**Chevy Chase Village
Board of Managers**

**CHEVY CHASE VILLAGE
BOARD OF MANAGERS
JANUARY 9, 2017 MEETING**

TO: BOARD OF MANAGERS
FROM: ELLEN SANDS, PERMITTING AND CODE ENFORCEMENT COORDINATOR
DATE: 1/5/2017
SUBJECT: CONTINUANCE OF CASE NO. A-6895 APPEAL OF THE MANAGER'S DECISION
MR. CHRISTOPHER IAN TWINN & MS. VICTORIA TWINN 5503 CENTER STREET &
MR. DAVID LEE & MS. JULIA LEE, 5505 CENTER STREET
APPEAL OF THE VILLAGE MANAGER'S DECISION TO ISSUE BUILDING PERMIT #6879 (TO MR. DAVID J.
ROSE AND MS. MEGAN L. ROSE OF 5502 GROVE STREET) TO CONSTRUCT A FENCE MEASURING SIX
FEET, SIX INCHES (6'-6") IN HEIGHT AND A RETAINING WALL MEASURING A MAXIMUM OF THREE (3)
FEET IN HEIGHT ABUTTING THE REAR PROPERTY LINE.

DRAINAGE REPORT FOR 5502 GROVE STREET IN CHEVY CHASE, MARYLAND

Figure 4: Contour lines and watershed limits before the grading

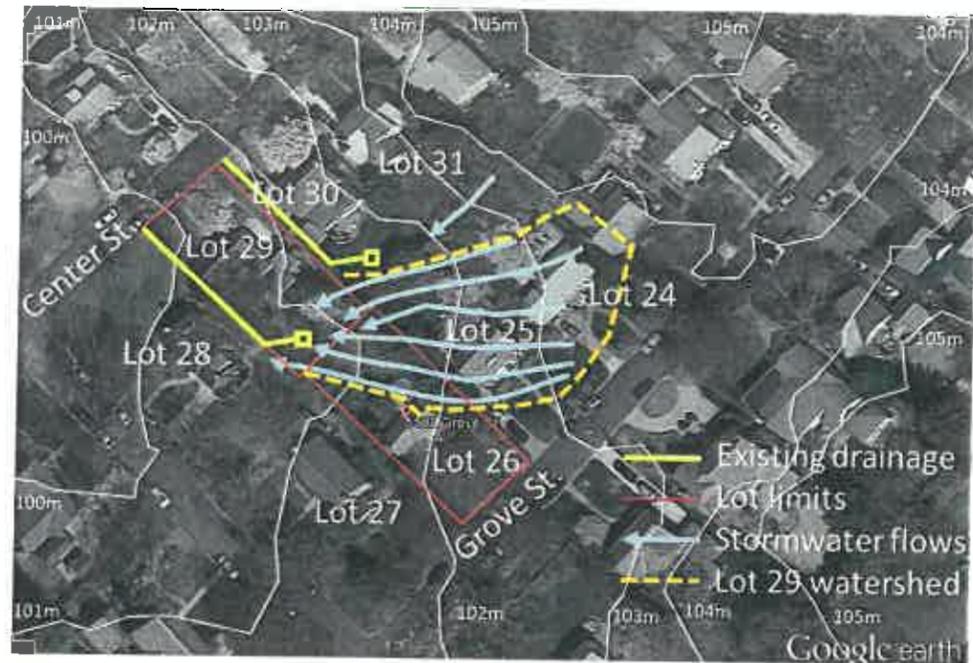
Once the wall has been built, when the rain is light and the soil can absorb it, no major changes have been detected. The problem occurs when it rains heavily and the water flows too fast or the ground is saturated and cannot absorb additional water. The current drainage systems in Lot 29 and Lot 30 was designed after a careful and systematic analysis of the water flows entering those yards but the grading works have introduced 2 main changes regarding storm water configuration that make less efficient the drainage systems and directly affects other lots around. These changes affect the watershed and the water flows:

Figure 5: water flows in Lot 26 before grading

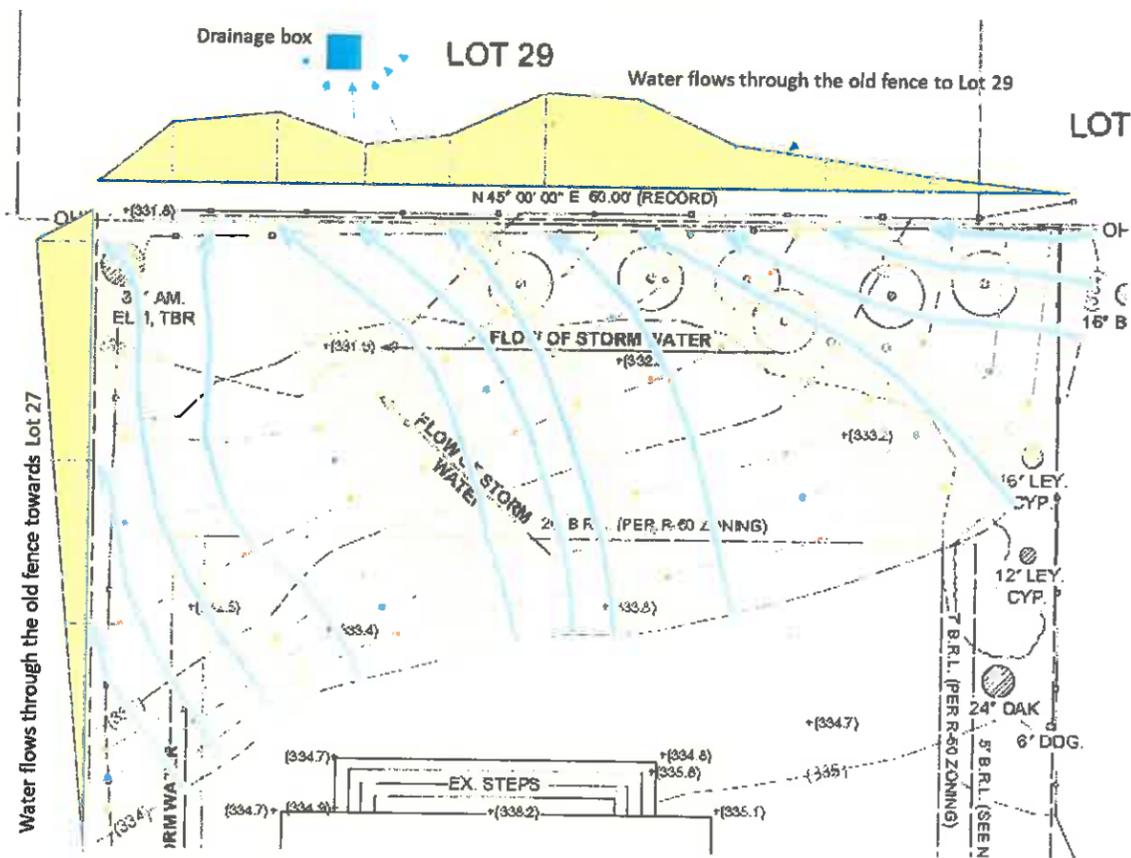
The **water flows** are the paths the surface water follows according to the land profile when it flows by the steepest downwards slope (perpendicularly to the contour lines). The water flows define how the water from the watershed enters the back yard of Lot 29. See figure 5 for details on how water used to flow from Lot 26 towards Lot 29. For this purposes, additional contour lines have been interpolated based on the information of the original proposal.

Figure 8: Proposal from the owners of Lot 26

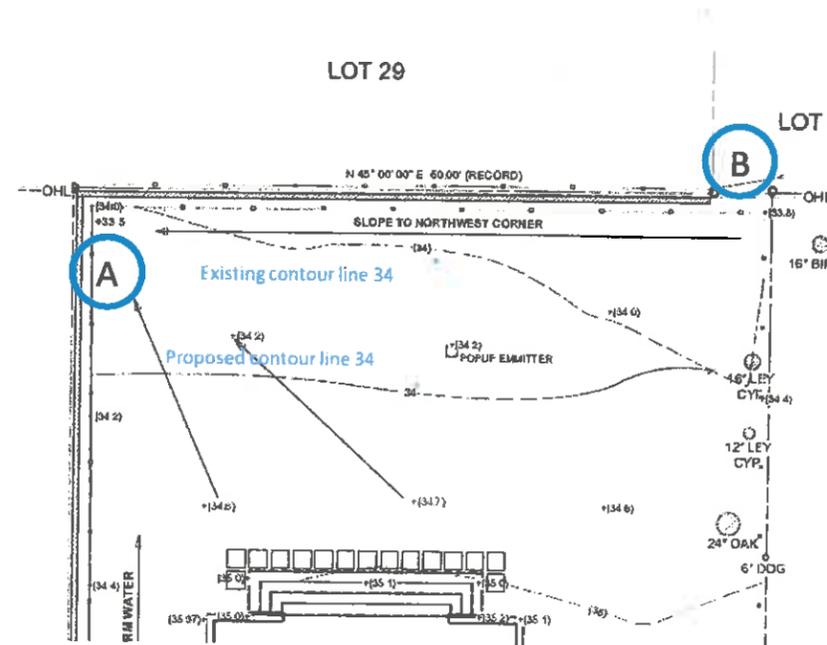
Unfortunately, the solution described in the drawing (figure 8) provided by the advisor to the Roses does not have enough information to judge it. It might be because of some missing pages or because there is a lack of definition. Apparently it seems that some soil will be removed close to the wall to allow water flow towards Lot 29 or Lot 27 through the wall. In any case, there is missing information about land height:

- Detail of the land height in the area close to Lot 29: What will be the slope towards Lot 27 (northwest corner ie. area A in figure 8)? Will it be lower than the point where there is no wall (Lot 25 ie. Area B in figure 8)?
- Detail of the land height in the area close to Lot 27: Will the water from the popup emitter flow again towards Lot 27?

Apparently, there is a number of problems that will not be solved:

- The watershed seems to remain as it is right now, since the popup emitter will pour water towards Lot 29. That means that additional water will be flowing to Lot 29 instead of flowing to Lot 27 as before and frequent floods will occur since the drainage system installed in Lot 29 will be overloaded.

- The only way that water may find to flow towards Lot 29 is through the wall, and consequently only filtered water through the ground will make it. The flow of water through filtered soil is significantly less than the flow at the surface, so only a little amount of the water will be filtered and most of it will flow on the surface. Since the proposal is undefined, *the only efficient solution is to remove the soil at a lower level than the shown in photo#1 of figure 1 (where the wall ends) and make proper drainage holes in the wall. Otherwise, the water will accumulate and will flow again under the fence where there is no wall and it is currently the lowest point in Lot 26 (area B).*

The popup emitter that brings the water from the roof should be moved to a place where the water only could pour to Lot 27, according to the previous situation (figure 11) to avoid increase the amount of water flowing to Lot 29.

SCHMATIC GRADING AND
SUBSURFACE DRAINAGE PLAN
DATE: 08-15-11
SCALE: AS SHOWN
DRAWN BY: JLF
CHECKED BY: JLF

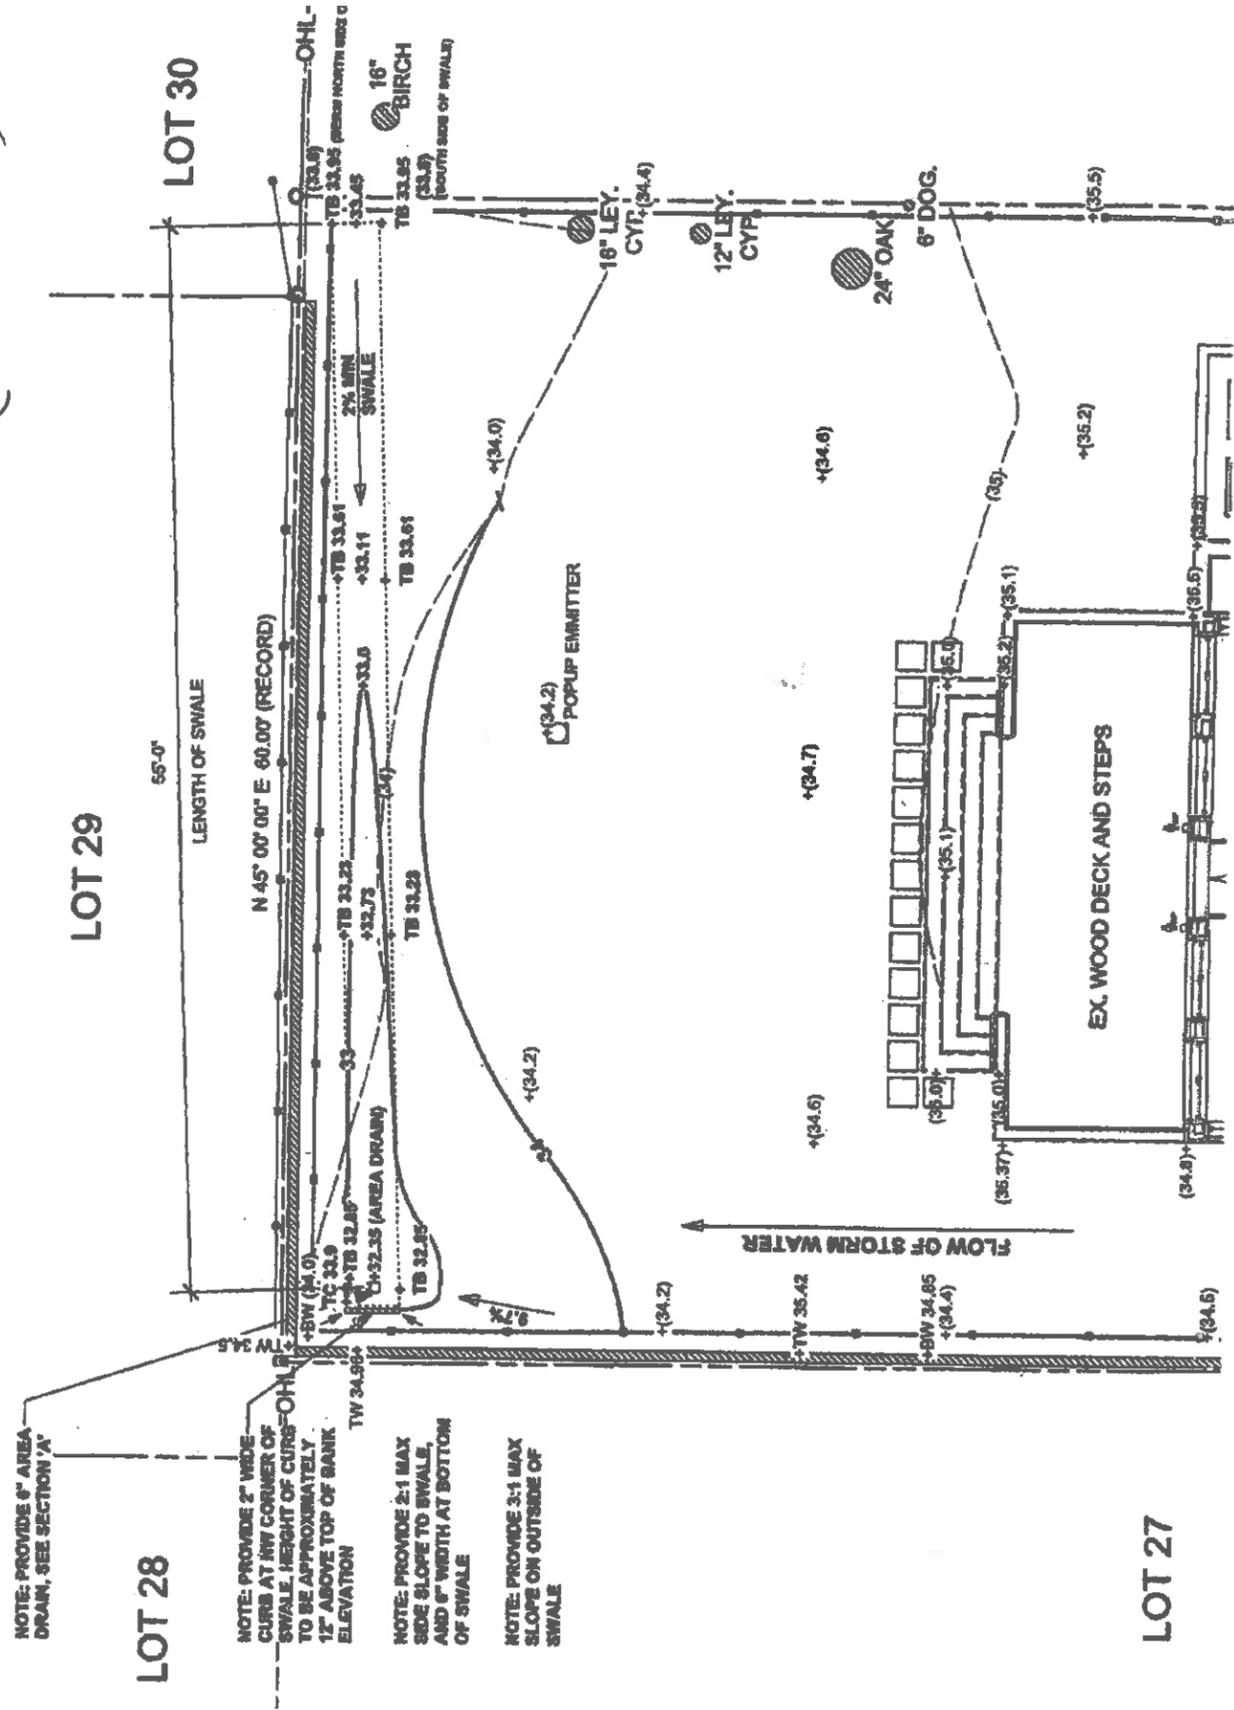
We believe that the solution prepared by the Landscape Architect, Lila Fendrick, in her latest submittal, dated September 27, 2016, should mitigate the current situation to a large extent. Her plans provide a swale (a shallow ditch) that intercepts the runoff from the adjacent lot at 5504 Grove Street (to the right of the subject property) and then directs it to an inlet in the

The proposal includes digging the current regrading in the area close to the Twinn's lot to create a swale parallel to the wall with a minimum 2% slope ending at the west side in a 6" box connected through a 4" pipe to the gravel behind the wood wall where the grading lays.

Despite of that, the proposal is not a solution because:

1. The new design **drainage capacity is not enough.**
2. It simply **transfers the problem to the owner of lot 28** by concentrating the water flow in a point closer to his/her property.
3. **The solution requires a periodic cleaning of the box grate** to be effective, might be several times a day in windy autumn days, and if this is not guaranteed the proposed drainage box will be useless.

Final Proposed Plan

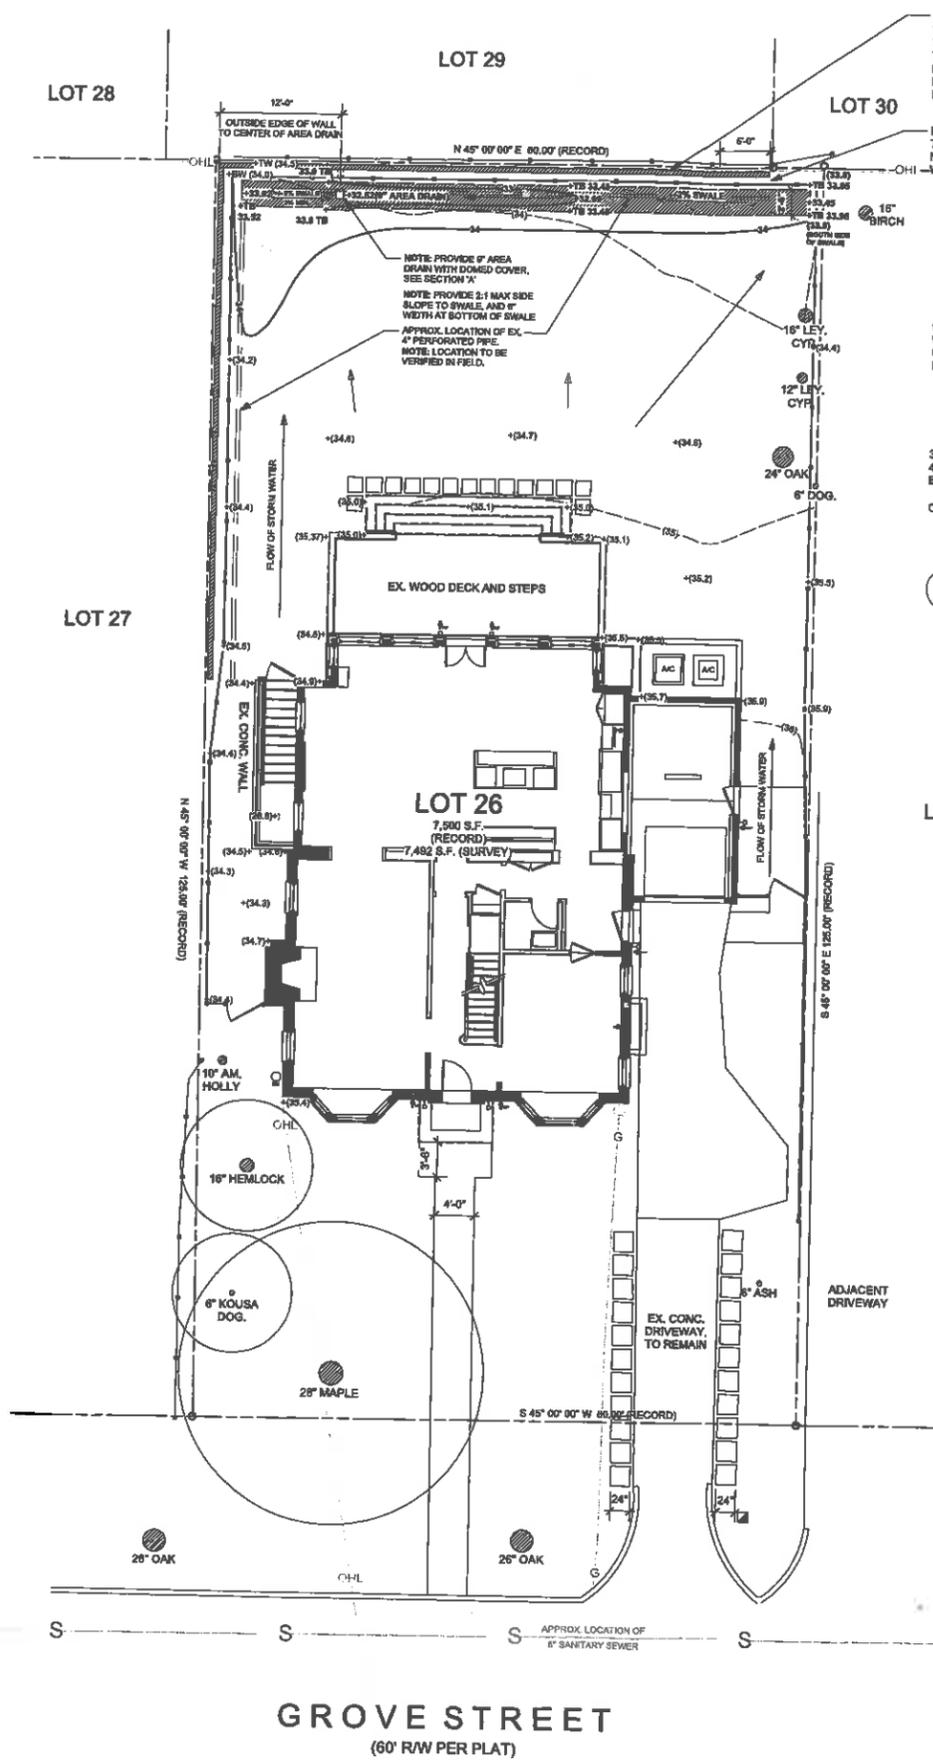
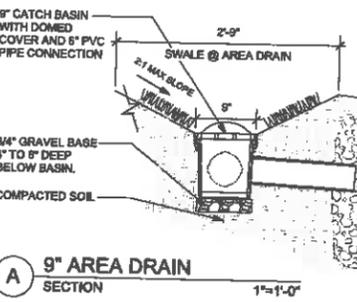
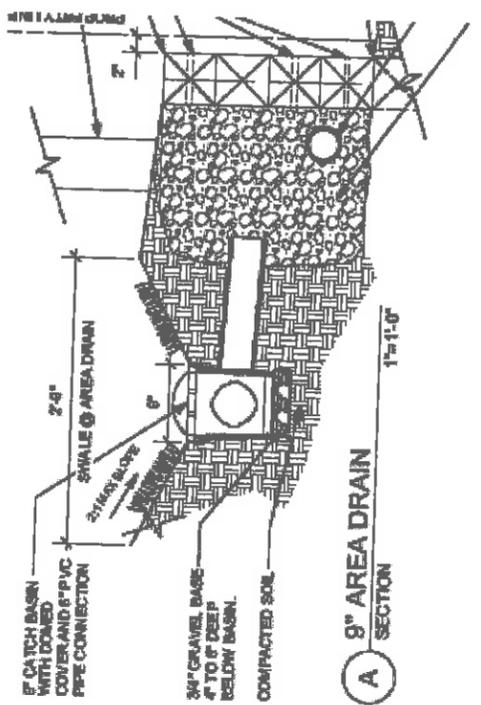
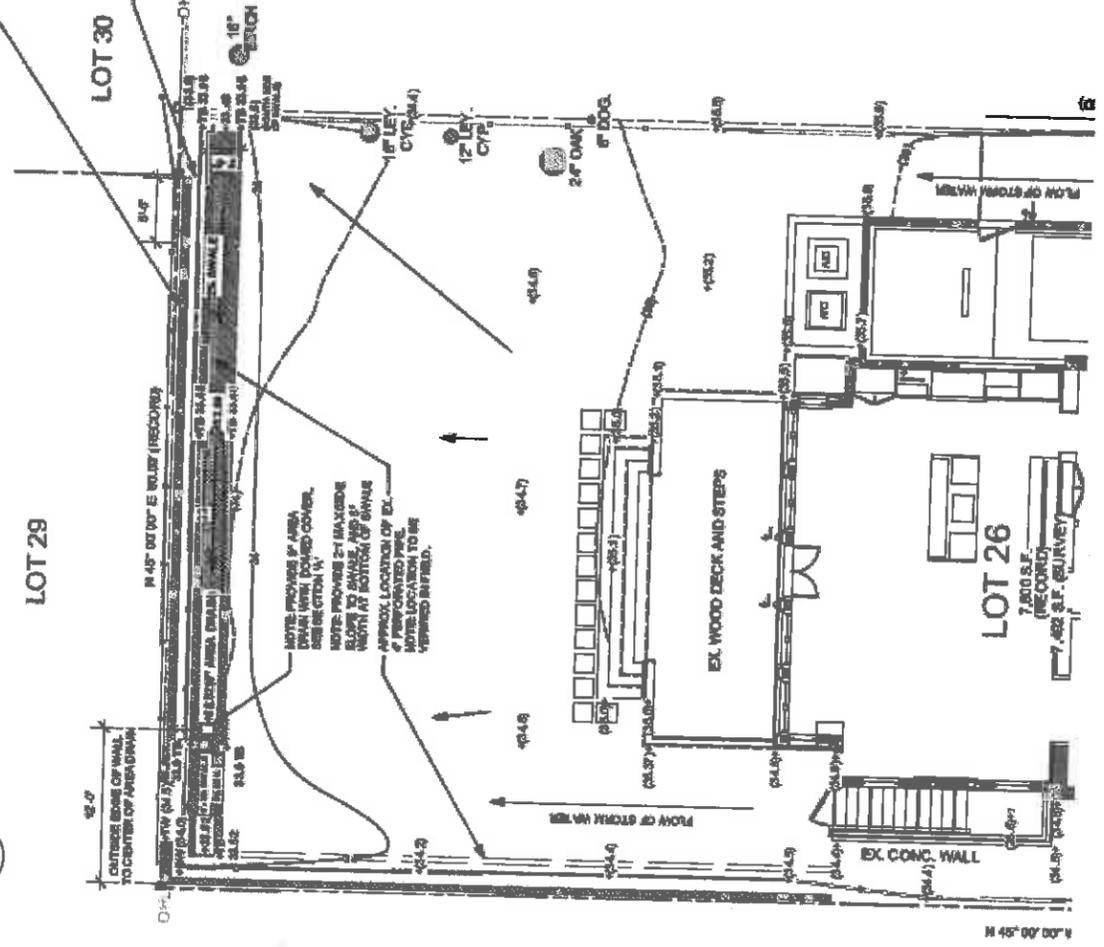
1. Catch Basin: At Mr. Twinn's suggestion, relocate the catch basin on the Rose's property so that it would direct the water in a manner that more closely resembles pre-construction flow patterns.
2. Provide a pathway for the overflow of water through the wall so that the water will not back up to the back rear of the Roses property and then flow to the Twinn's property.

Catch Basin: Placing the catch basin 10' to the right of the outside edge of the retaining wall is preferable to the current design. According to Mr. Twinn's observation, having the water flow out of the wall at this location should more closely resemble the pre-existing flow path of the runoff. This would also reduce the amount of grading on the Rose's property since the catch basin would be moved upgrade from its existing location. We do not believe that this would cause additional adverse impact to the adjoining property. Our concern is conveying the runoff, not storing it.

In order to reduce the likelihood that the catch basin would clog, a dome cover should be used. If this is not available for a 6" catch basin, a 9" catch basin should be used. Based on our site visit, it also appears that the distance of 10' to the right of the outside edge of the retaining wall may not ensure that water bypasses the catch basin on the Twinn's property. If the Twinn's and Rose's are in agreement, we recommend that the location of the catch basin be moved 12' to the right of the outside edge of the retaining wall. We were able to find a 9" catch basin with a domed cover on line at <https://drainagekits.com>.

We are not opposed to a suggestion made by Mr. Samos that a larger pipe (6" instead of 4") be used to convey the water from the catch basin to the gravel drain tile. We do not think that this will substantially change the intent of our design, and the cost difference should not be substantial. Ultimately, the catch basin in Mr. Twinn's yard is limited by the pipe capacity of the 3" pipe that conveys that water to the street.

NOTE: G.C. TO CAP EX. 4" PERFORATED PIPE BEHIND WOOD TIE WALL AND REMOVE 5'-0" LENGTH OF GRAVEL BEHIND THE NORTH EAST END OF THE WOOD TIE WALL. REPLACE GRAVEL WITH SUBSOIL.

NOTE: PROVIDE 9" AREA DRAIN WITH DOMED COVER. SEE SECTION 'A'.

NOTE: PROVIDE 2:1 MAX SIDE SLOPE TO SWALE, AND 8" WIDTH AT BOTTOM OF SWALE.
